Lesson to be learned in public presentations

General Description of Plant Fill Problem and Its Extent

List of Vu-graphs for ACRS Presentation - Geotechnical Engineering

FIGURE II-1 GES-52

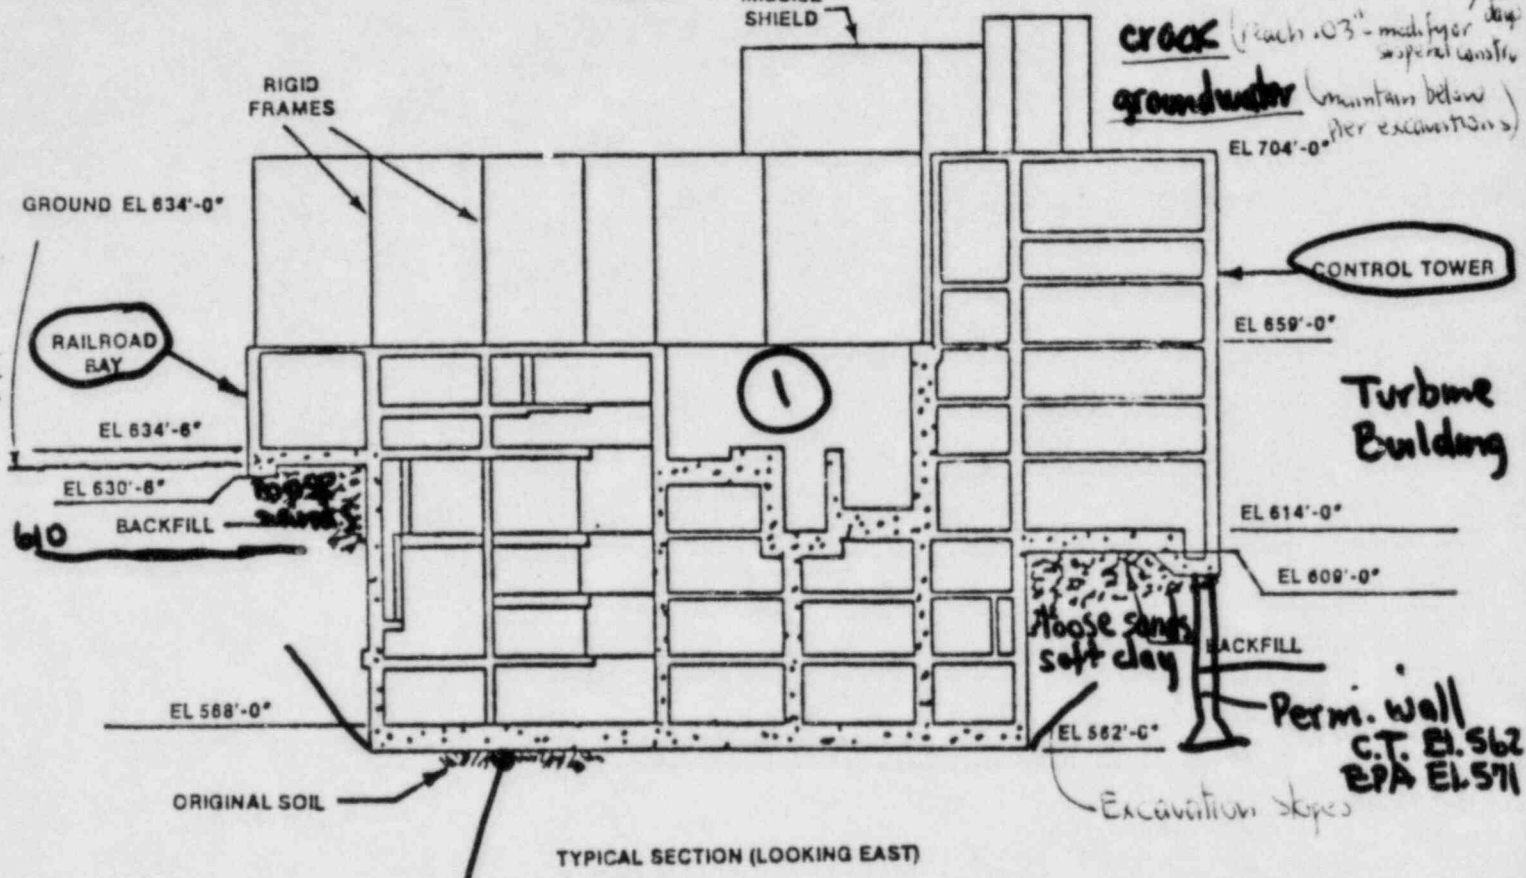
GES-52 Note that package has plan view but VU-Graph not available

Note individual structures

Note reactor containments are ^{NOT} connected to Main Auxiliary Bldg

Note that EPA, C.T., and RR piping are structurally connected

Give approximate dimensions of C.T. & EPA

Show section location for next VU-GRAPH

GRS-53

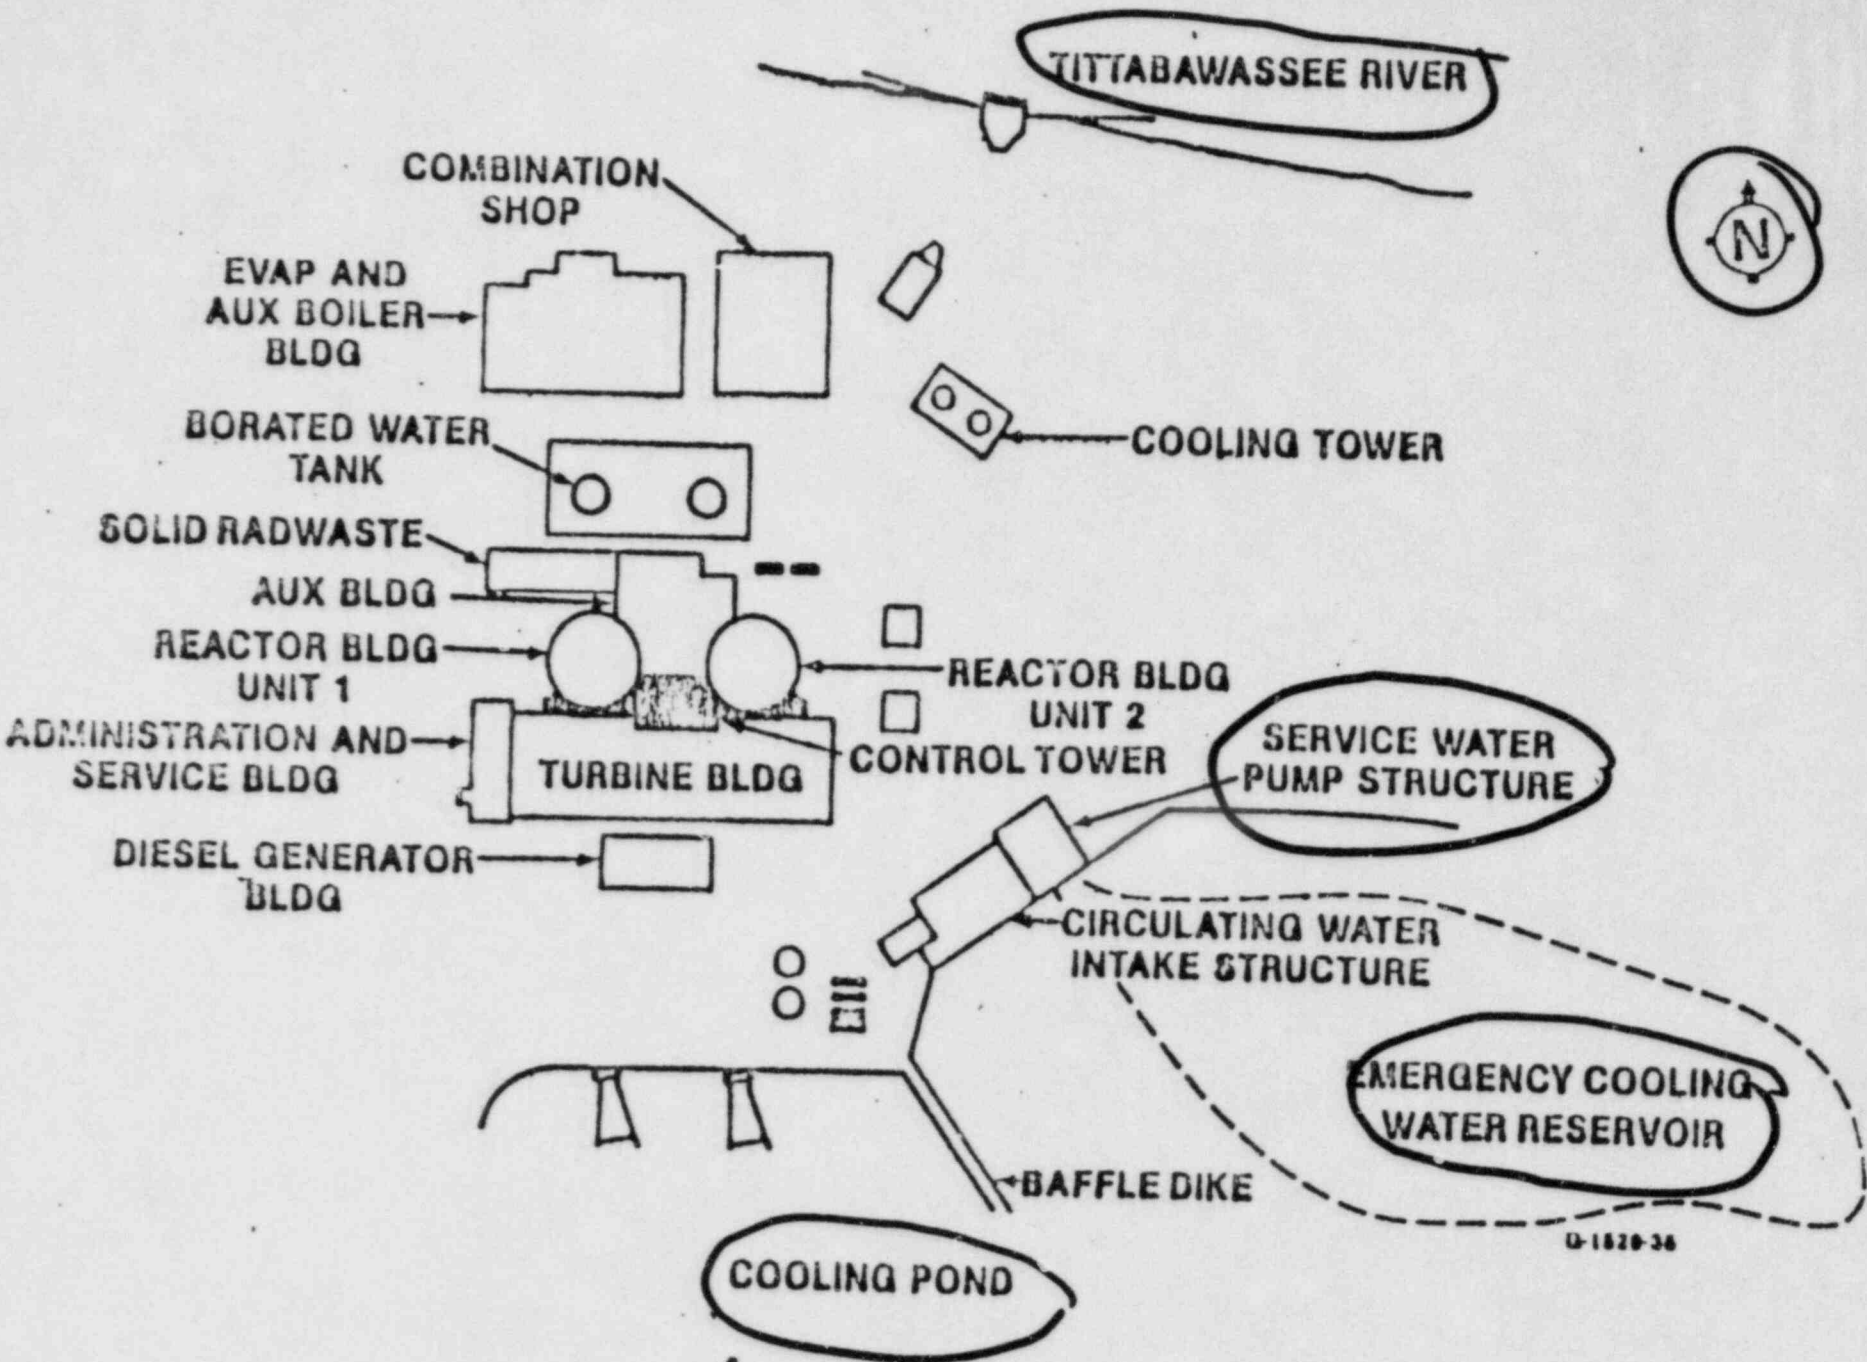
- Staff assessment of proposed underpinning fix:
- Provides a positive solution for eliminating foundation problem
 - EPA & C.T. loads will be transmitted to very competent foundation layer
 - Monitoring during construction will permit verification of foundation adequacy and will include:
 - check on bearing capacity (Cone penetrometer)
 - Allowable bearing pressure 6 KSF EPA
 - 8 KSF C.T.
 - 25 KSF Temp. pier base

Product - During work
2.6 EPA
0.9" C.T.

soil modulus (load test to establish clay modulus to verify long term settlement limits)

settlements (not exceed 0.05 inch last 30 days & not greater than 0.01 inch / 10 days)

② Foundation - Very STIFF & HARD CLAY (CL)
 Median blow counts = 56 blows/ft
 LL 42, PL 20, $w_{nat} = 20\%$
 fines 90 to 98% $\delta_{total} = 130pcf$
 Median undrained strength = 7.6 KSF

GES-55

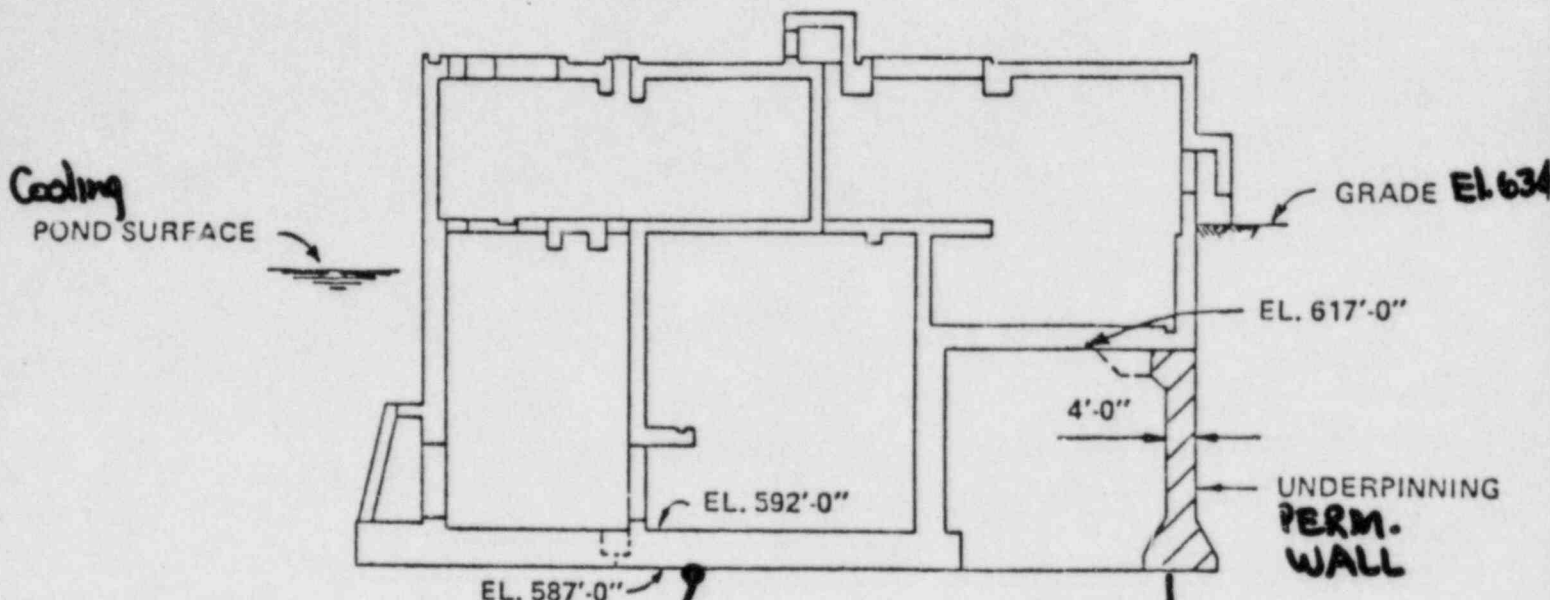
Portion on fill to be underpinned

Portion on till

GES-56

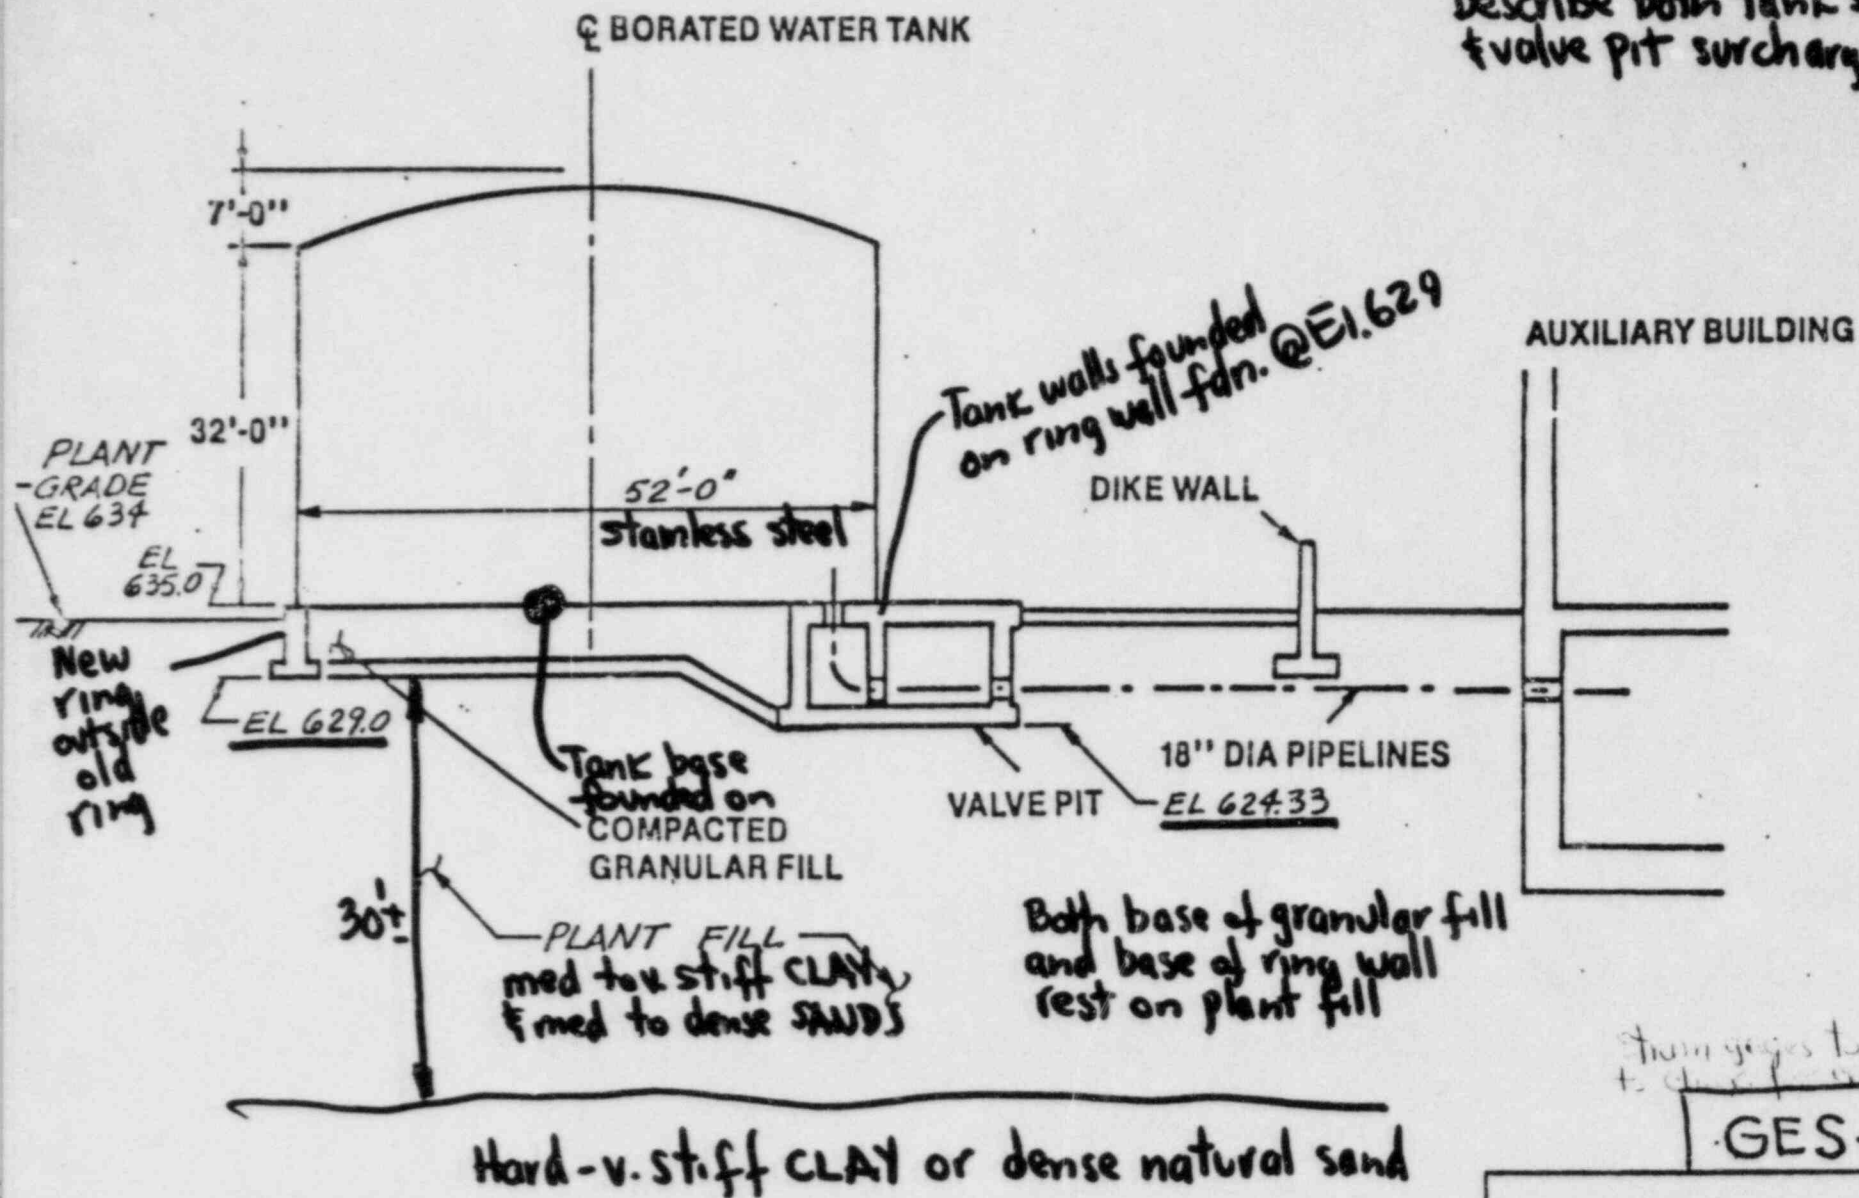
Foundation layer ^{will be} ~~is~~ a hard sandy CLAY ^{or a dense silty clay} fill, that has top elevation around 590
 (IV medium = 75 blows (range 50 to 120), LL 17, PL 11, $w_n = 17\%$, $S_{total} = 145\%$, $S_{dry} = 134\%$
 $f = 50$ to 70% , ^{adapted} ~~medium~~ undrained shear strength of 8 ksf E of 6,000 to 9,000 ksf.
 Preconsolidation stress up to 40 tsf)

The Staff and its Consultants concur with the Applicant that the hard sandy CLAY ~~and dense silty clay foundation~~ ^{is} ~~are~~ competent and acceptable foundation materials to support the proposed permanent underpinning wall and thereby eliminate the plant fill problem in the SWPS area.

Foundation monitoring during construction will include checking groundwater, verifying adequate bearing capacity, soil modulus, settlement characteristics and controlling maximum elevation differences between adjacent pier bottoms

Staff assessment

- Piers will be founded on very competent foundation layer
- Positive solution will eliminate plant fill problem
- Monitoring during construction will permit verification of foundation adequacy

Foundation
 Hard sandy CLAY TILL
 Top Elev. \approx 590
 Median N = 75 blows/ft (50 to 120)
 LL 17, PL 11, $W_n = 9\%$ $\gamma_t = 145 \text{ pcf}$
 $\gamma_{dry} = 134 \text{ pcf}$
 fines 50 to 70%
 Adopted undrained shear strength = 8 KSF
 Heavily preconsolidated (98 tsf) $E = 6000 \text{ to } 9000 \text{ KSF}$

GES-57

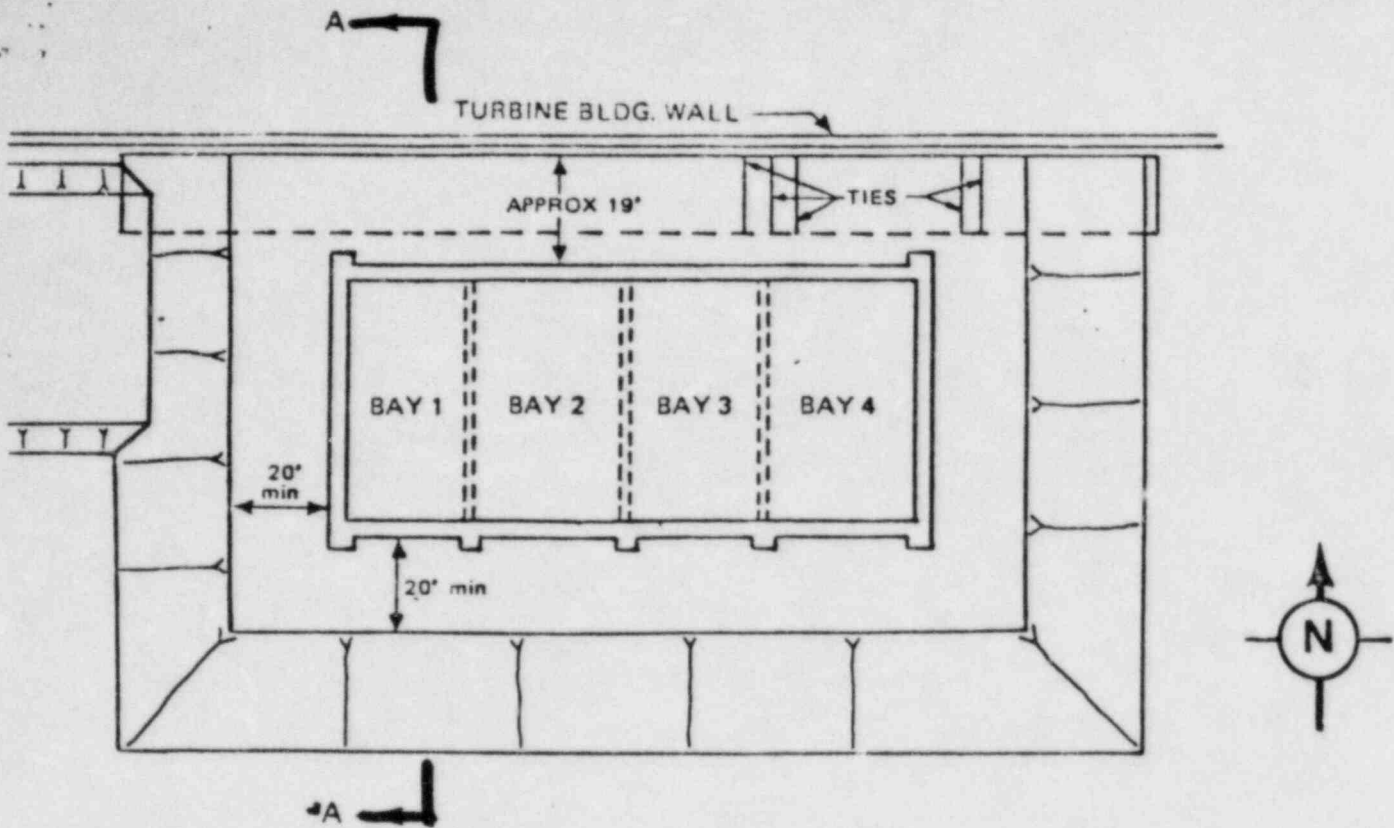
The ~~base~~ base of the tanks are founded on a compacted granular fill and the tank walls are founded on a ring wall foundation at elevation 627. The base of the granular fill and the base of the ring wall are founded on compacted cohesive fill that is approximately ^(CL-MU) 3 feet thick. Below the fill lies either hard-very stiff clays or in some locations dense natural sands. The fill itself consists of medium to v. stiff clay with medium to dense natural sand ✓

To demonstrate the adequacy of the BWSJ foundations, the Applicant filled the tanks with water to surcharge the plant fill. Shortly thereafter cracks (0.63 inch limit 1 & 0.35 inch limit 2) were discovered in the ring wall foundation near the juncture of the tanks and the valve pit structures.

Differences in technical opinion do exist between the Staff and the Applicant as to what was the major cause of the cracking. **a design inadequacy where a non-unif.**

Applicant - Major cause was ~~non-uniform~~ loading between valve pit and ring wall which resulted in differential settlements and localized areas of over stress

Staff - Consider the major cause to be inadequate compaction that lead to unanticipated larger settlements

Strain gauges to be installed to check for settling

In spite of these differences - the Staff and Applicant have reached agreement on the acceptability of the proposed fix

that of constructing a new reinforced concrete ring beam around the existing ring beam and releveling Unit 1 tank (Suffered the largest settlement). Mr. Rinaldi to discuss.
New ring beam has been designed allowing for conservative estimates of differential settlement in the future

BWST foundation settlement will be monitored during years of plant operation as well as the critical stress areas between valve pit and the ring wall with a strain gage system. The objective of the monitoring will be to verify that differential settlements estimated in the redesign of the new ring beam are not exceeded and that ^{significant} cracking is not occurring
